Errata

Applies to IP65 step motors from pilot production build

Motors with orange, orange/white, red, red/white, black, black/white, yellow, yellow/white.

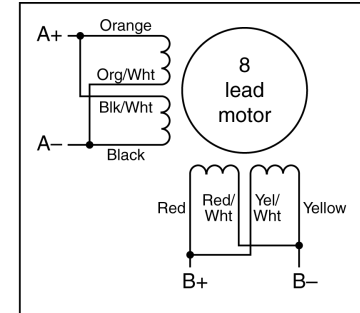
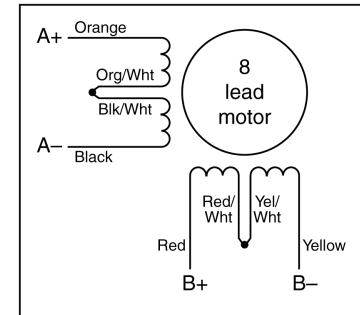
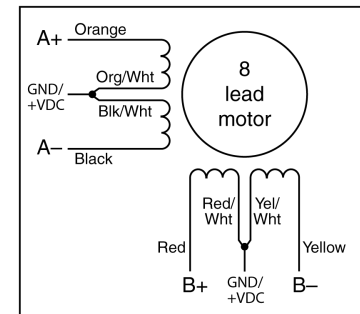
1. Some units have cables that are rated 80°C. These motors should be operated such that the case temperature does not exceed 80°C.
2. The wire colors may differ from our standard. See wiring diagrams below and on the back.
